Access Compliance Report Public Rights-of-Way (Curb Ramps)

Intersection ID: 14410 Main Street: DUNAVANT ST Cross Street: S_TRYON_ST Location:

ADA ID: 197BEC31987E Ramp Type: PerpDiag Initial Pass/Fail: Fail **Overall Compliance: No Severity Score:** 12.5

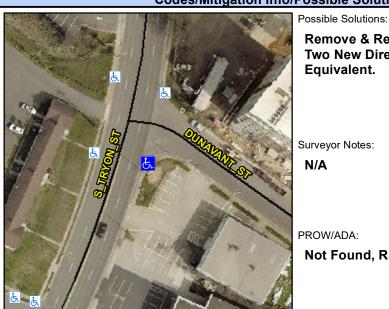
Not Found, R304.2.2

Comp	oliance Description	Data	Comp	liance Description	Data
N/A	Ramp Length (in)	57.0	No	Ramp Slope (%)	10.2
Yes	Ramp Width (in)	48.0	Yes	Ramp XSlope (%)	1.1
N/A	Flare Type LT	N/A	N/A	Flare Type RT	N/A
N/A	Flare Slope LT (%)	N/A	N/A	Flare Slope RT (%)	N/A
N/A	Flare Traversable LT?	N/A	N/A	Flare Traversable RT?	N/A
N/A	Landing Length (in)	N/A	N/A	DWS Provided?	N/A
N/A	Landing Width (in)	N/A	N/A	DWS Contrast?	N/A
N/A	Landing Slope (%)	N/A	N/A	DWS Length (in)	N/A
N/A	Landing X Slope (%)	N/A	N/A	DWS Full Width?	N/A
N/A	Landing Curb? (Y/N)	N/A	N/A	DWS Offset (in)	N/A
N/A	Shared Landing?	N/A			
N/A	Gutter Ponding?	N/A	N/A	Gutter Slope (%)	N/A
N/A	Gutter Lip Ht (in)	N/A	N/A	Gutter X Slope (%)	N/A
N/A	Painted X Walk1?	No	N/A	Painted X Walk2?	No
	X Walk 1 Direction	To N		X Walk 2 Direction	To W
N/A	X Walk 1 Width (in)	N/A	N/A	X Walk 2 Width (in)	N/A
	X Walk 1 Slope (%)	2.3		X Walk 2 Slope (%)	3.0
	X Walk 1 X Slope (%)	0.5		X Walk 2 X Slope (%)	1.6

Remove & Replace Curb Ramp With Two New Directional Ramps or Equivalent.
